Application Number: 260568

Site Address: Arborfield Green District Centre, Arborfield Green, Arborfield, Berkshire

Proposal: Application for submission of details to comply with the following condition of planning consent 230872 dated 18/10/2023. Condition 13 relating to Visibility Splays for Private Drives.

MEMORANDUM

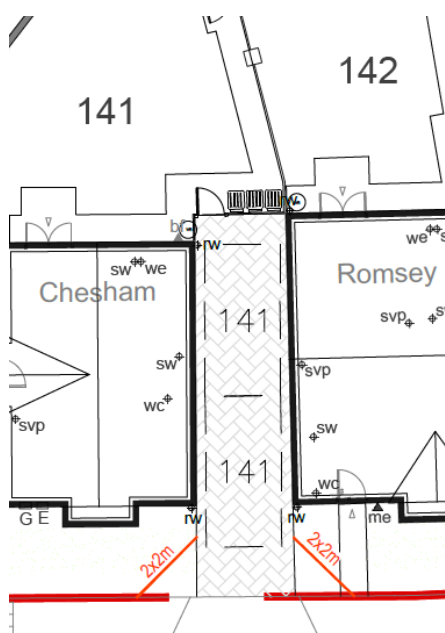
In some locations, it is noted that visibility splays for some private driveways cross the land of another property, for example shown below for the left splay for 141 crossing the front garden and a small part of the footway for 142:

In practice, it is acknowledged that this would unlikely cause an issue, however there should be a covenant on land within approved visibility splays to ensure that owners cannot build or obstruct the splay above a height of 0.6m.
